Remarks

Applicant will address the objections and rejections raised in the Office Action using the paragraph numbers from the Office Action.

FIG. 1

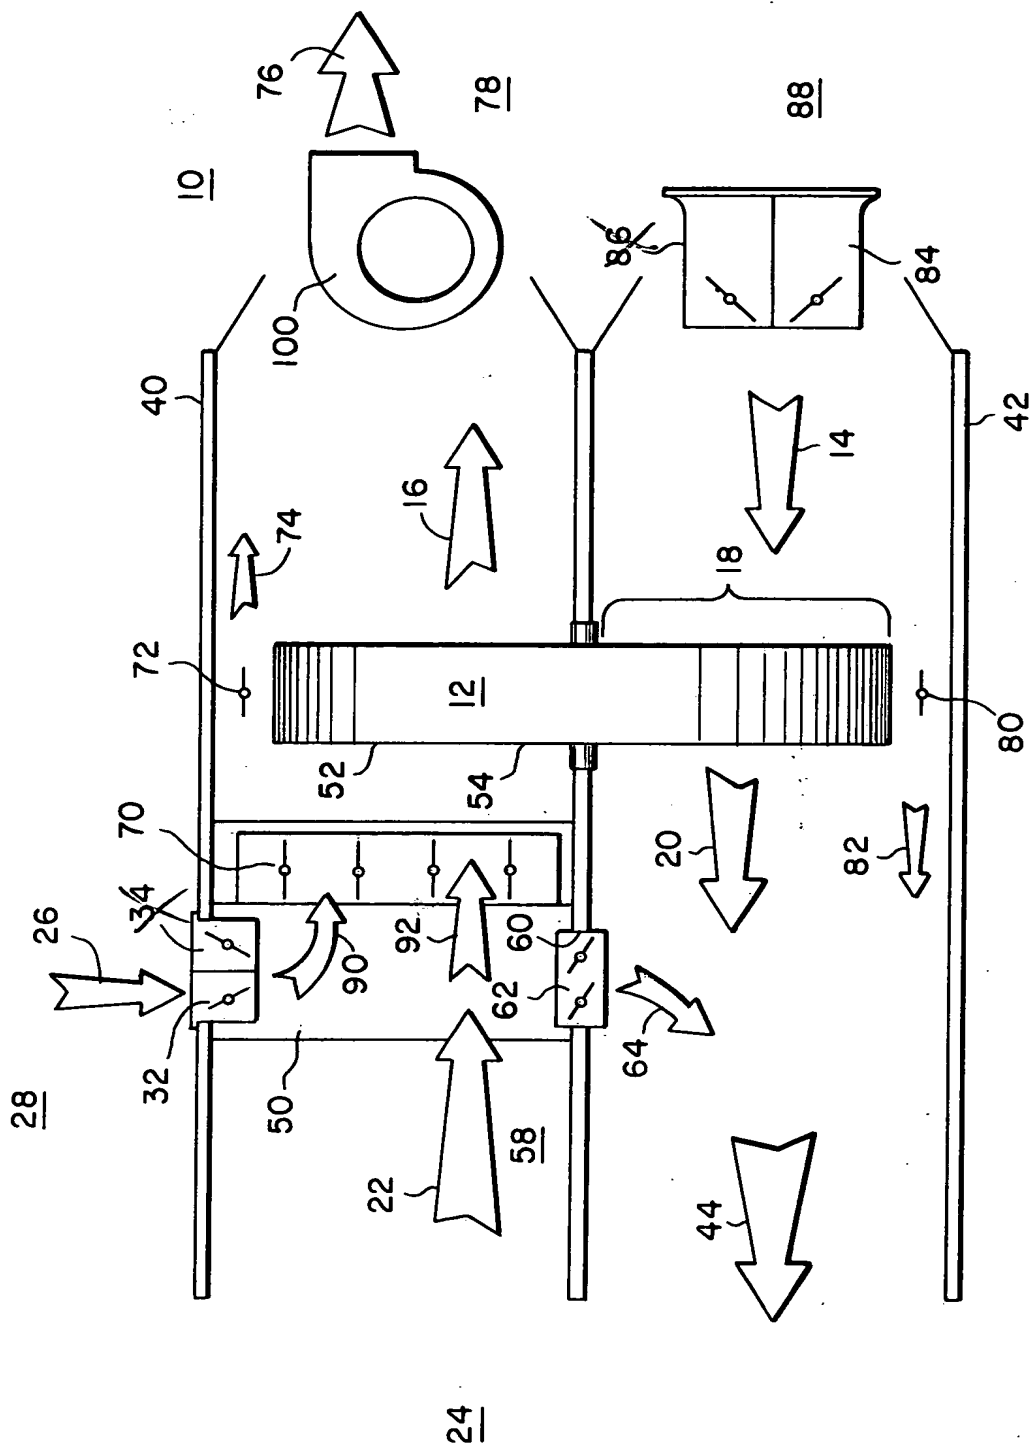
Drawing Objections in Numbered Paragraph 7:

Replacement sheet 1 has been submitted deleting reference numerals 34 and 86 and their respective lead lines. A highlighted version of the drawings is also attached to show the deletion of reference numerals 34 and 86 and their lead lines from Figure 1. Inasmuch as the Figures 2 and 3 are believed to clearly show the damper and sensor relative to reference characters 32, 34, 84 and 86, the deletion of these reference characters from Figure 1 is believed to resolve the drawing objection raised in numbered paragraph 7.

Please submit the amended Drawing Figure 1, Sheet 1, attached hereto in place of the Drawing Figure 1, Sheet 1, currently on file.
